Agenda  
Village of Glen Ellyn  
Plan Commission  
Regular Meeting  
Thursday, May 24, 2018  
7:00 PM

**D. Public Hearing - 840-944 Roosevelt Road - Pete's Market/Baker Hill Shopping Center - PUD Amendment and Sign Variations**

**TO:** Glen Ellyn Plan Commission  
**FROM:** John Sterrett, Planner  
**DATE:** May 18, 2018  
**FOR:** May 24, 2018 Plan Commission Meeting  
**SUBJECT:** Public Hearing – 840-944 Roosevelt Road – Pete’s Market/Baker Hill Shopping Center Amendment to the Baker Hill PUD and Variations from the Sign Code

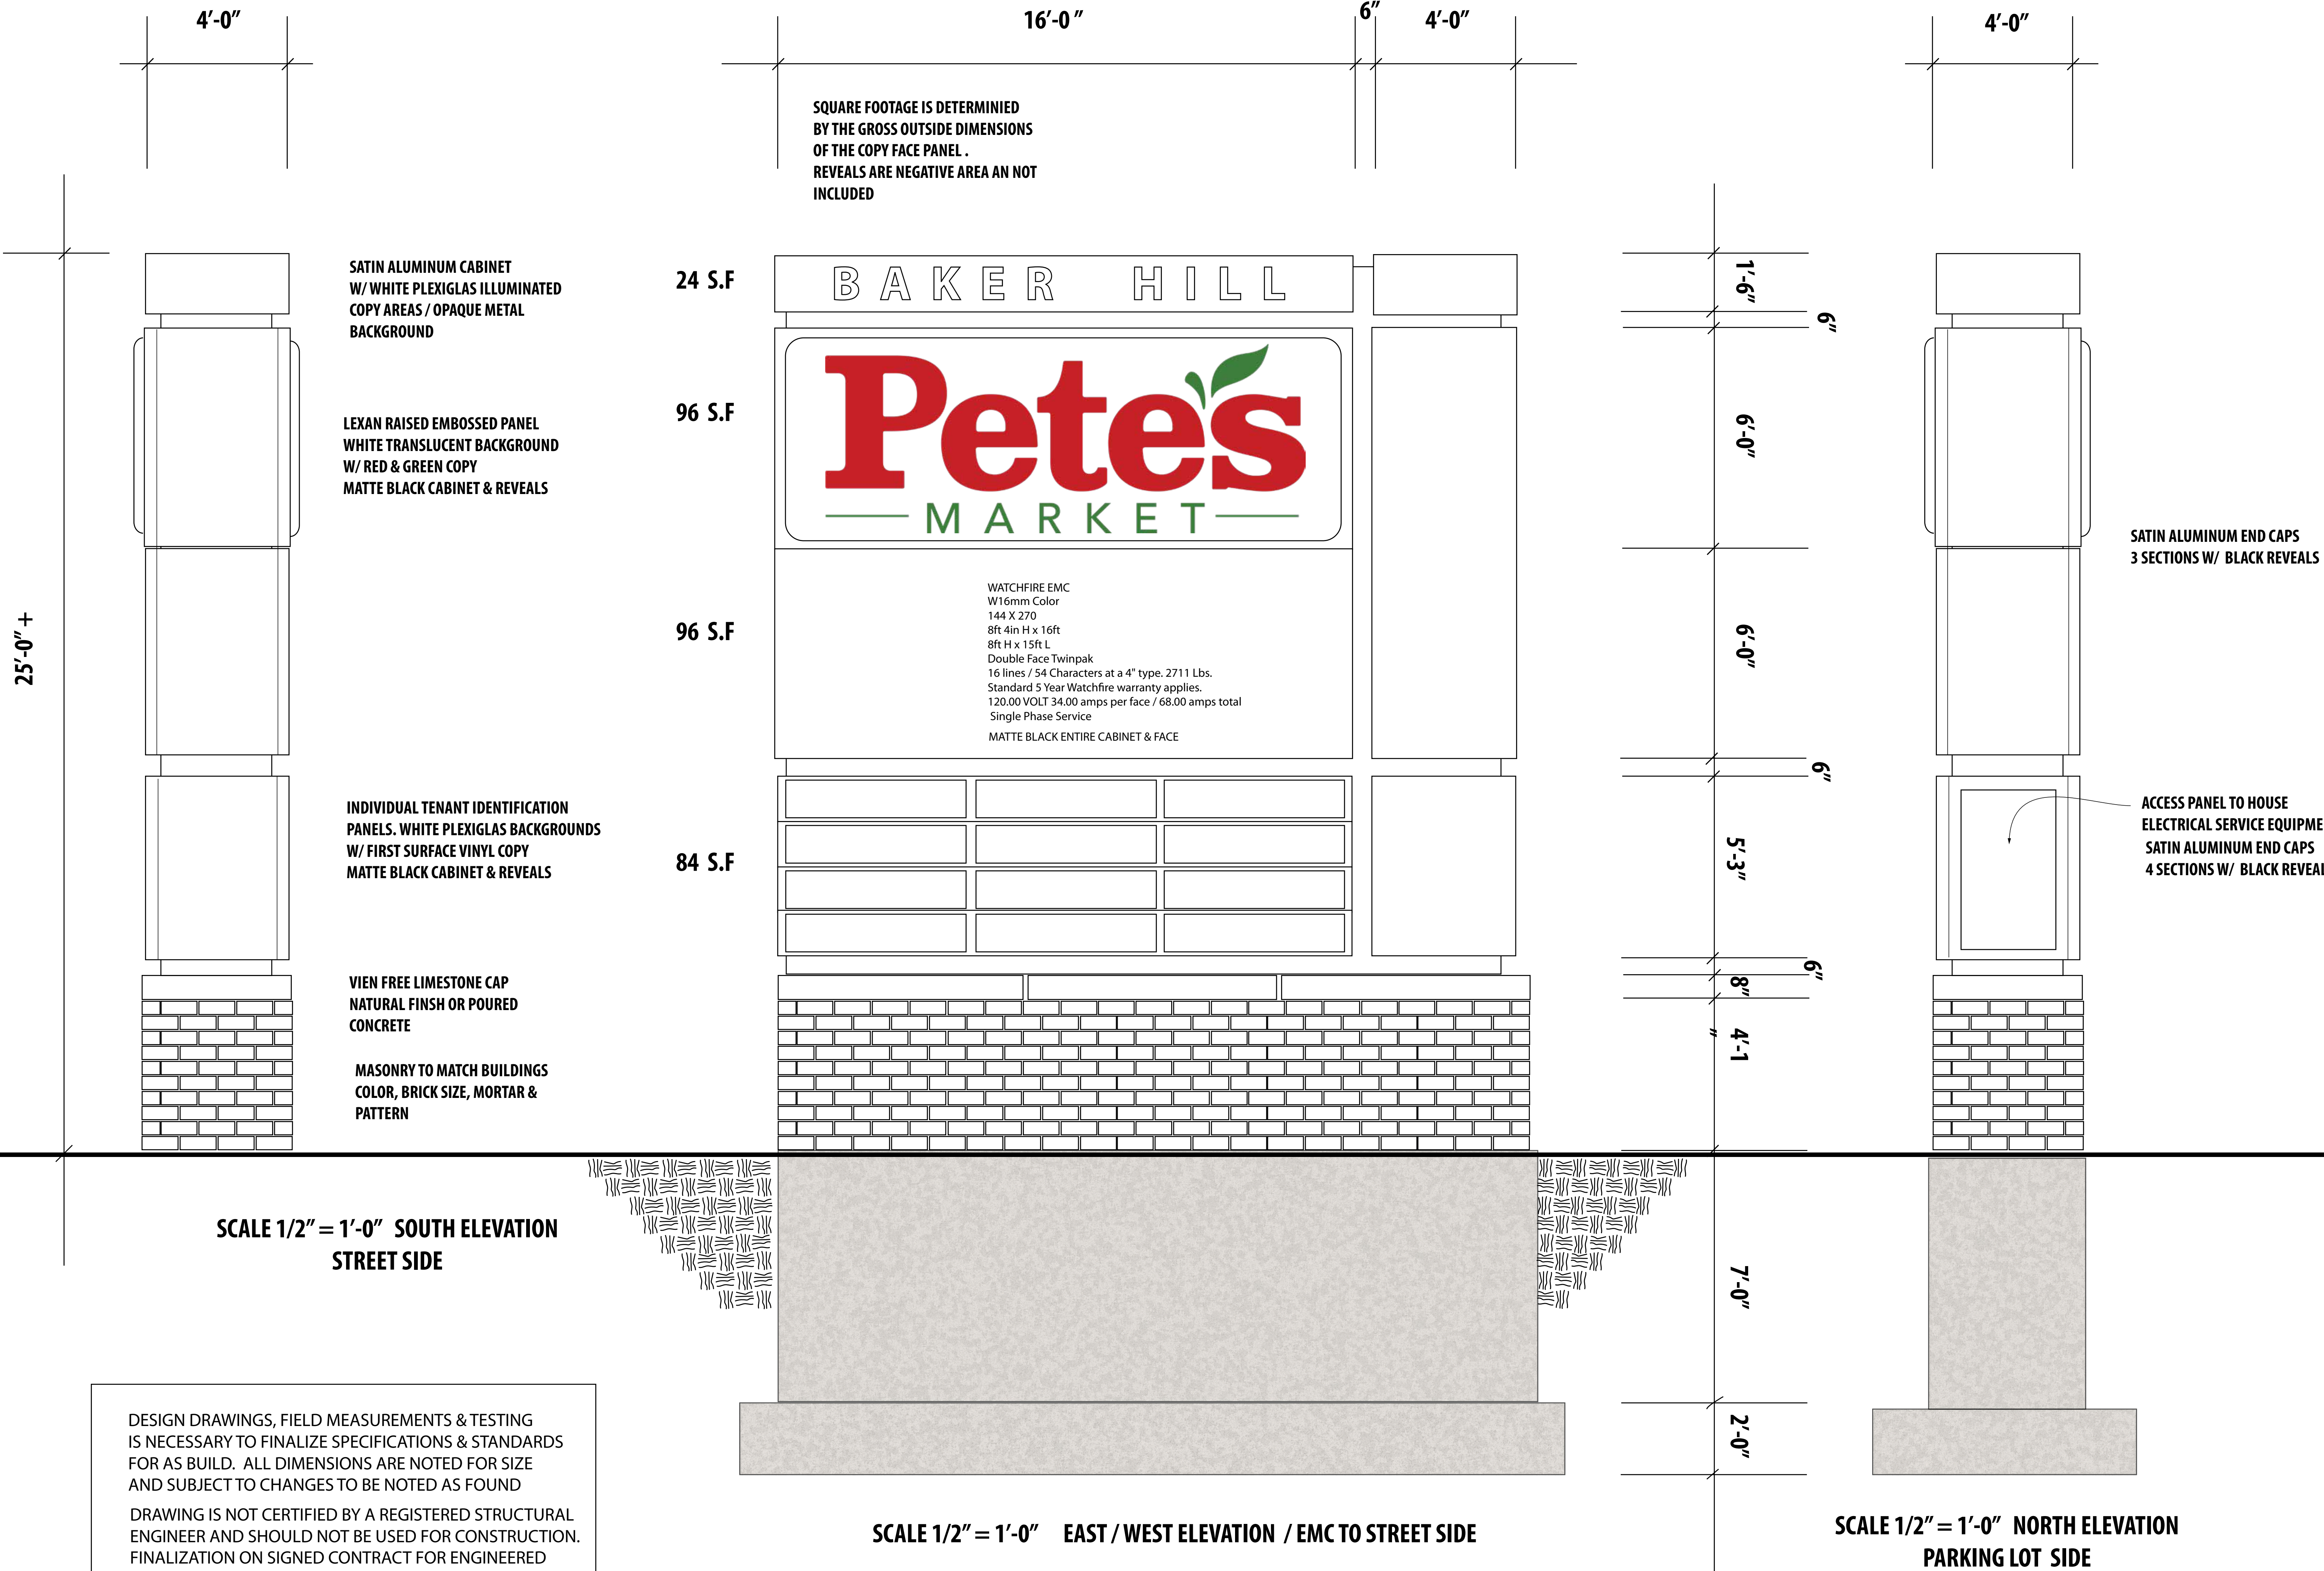
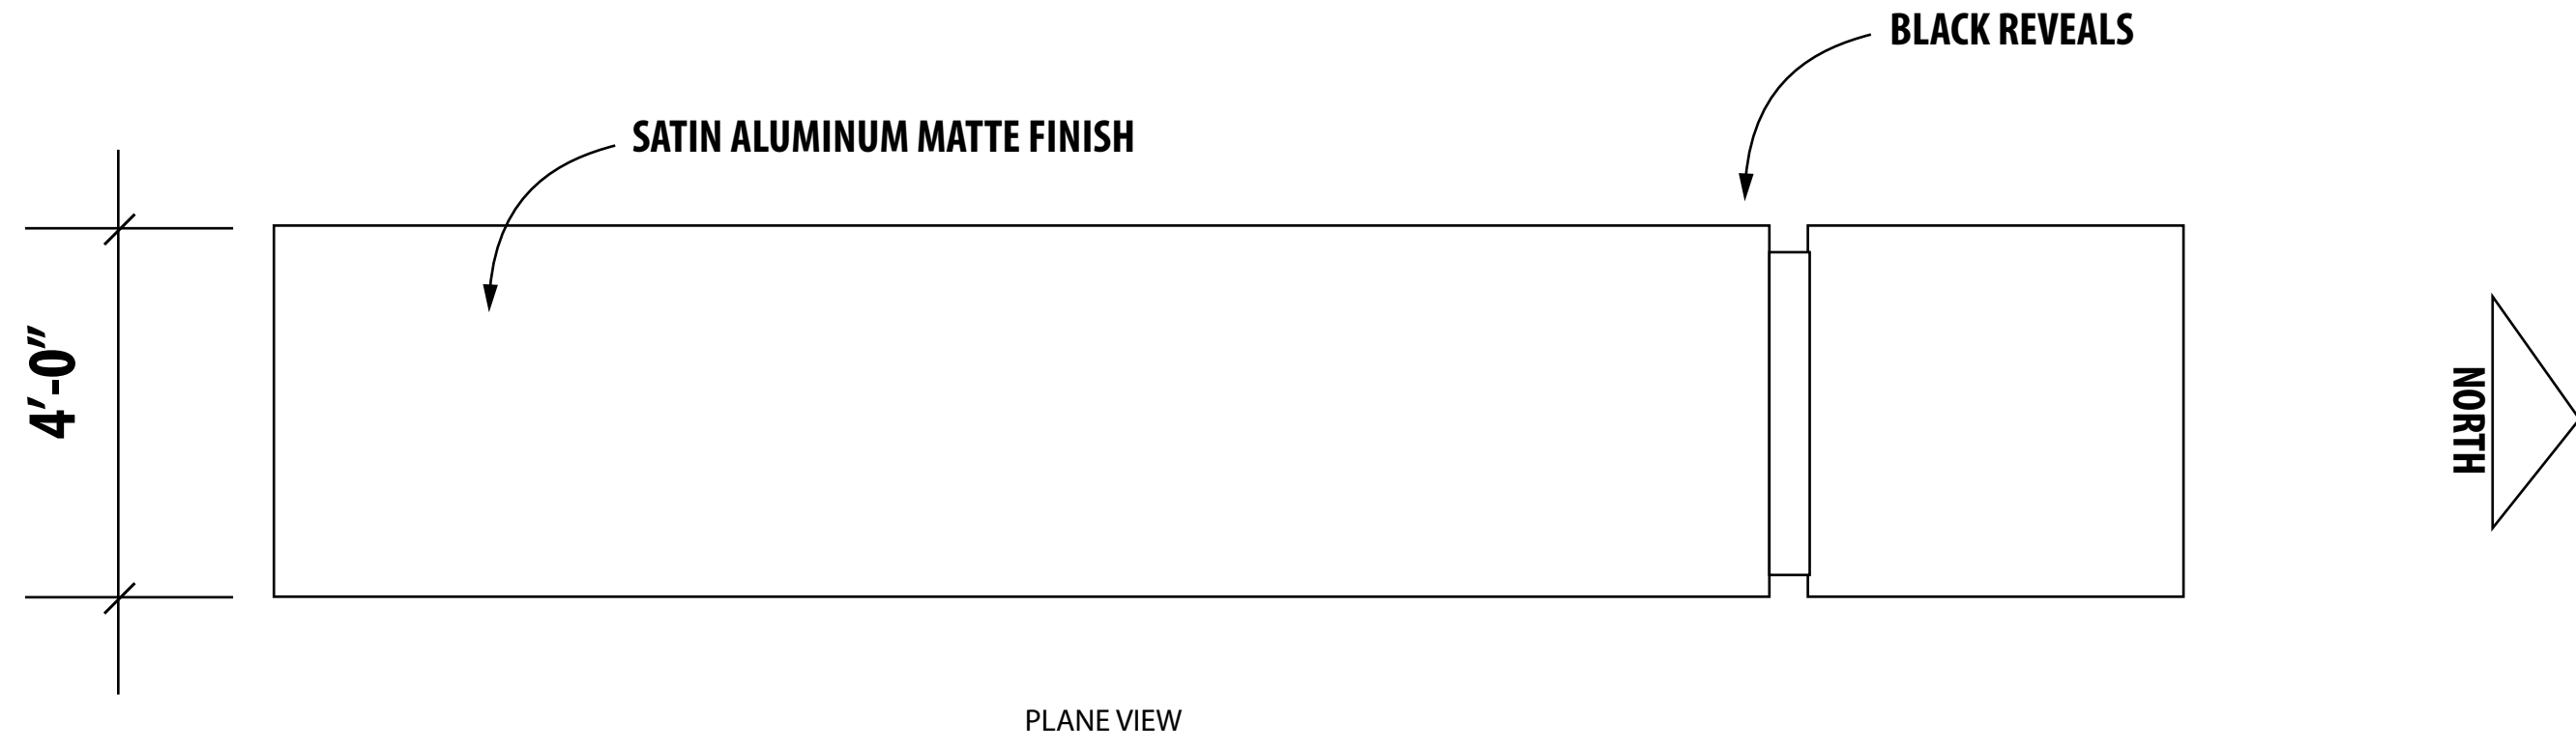
**Freestanding Signage.** Phillips Edison is proposing to remove an existing 10 foot tall, 50 square foot freestanding, multi-tenant sign and replace it with a 25 foot tall, 300 square foot freestanding, multi-tenant sign. The base of the sign will have a height of 4'-9" and will be constructed with masonry to match the color, brick size, mortar, and pattern of the shopping center building.

This text amendment has not been approved nor has been heard by the Plan Commission at a public hearing and therefore the current setback requirement of 5 feet is still in effect. The Plan Commission may wish to request the petitioner shift the sign further to the north to increase the distance from the property line so it will be closer to compliance with the new regulation. The furthest north the sign can be shifted without impacting the parking lot is 4 additional feet. The sign in its proposed location will still maintain a sufficient distance of 25 feet from the edge of the Roosevelt Road pavement. The sign will maintain a distance of 220 feet from the exiting lane from the shopping center onto Roosevelt Road. The access onto Roosevelt Road from the site is currently right-out only. Staff, therefore, does not believe the location of the sign will impact site distance at the entrance to the shopping center.

Place, which contains 3 freestanding signs ranging from 37 square feet to 85 square feet and heights ranging from 13 feet to 19 feet. The Plan Commission may wish to suggest the total square footage of the proposed sign be reduced to be closer in size to the signs at other shopping centers.

Regarding the proposed sign height, both Market Plaza and Pickwick Place are located in relatively flat areas and have little grade change along Roosevelt Road. The portion of Roosevelt Road adjacent to Baker Hill, on the other hand, drops from 762 feet above sea level at Baker Hill Drive down to 718 feet above sea level at the eastern property line of the shopping center. The location of the proposed sign is 740 feet above sea level, which sits approximately 22 feet lower than the nearest intersection of Roosevelt Road and Baker Hill Drive. This location is also 22 feet higher than the eastern property line. The proposed sign height, therefore, does not seem unreasonable.
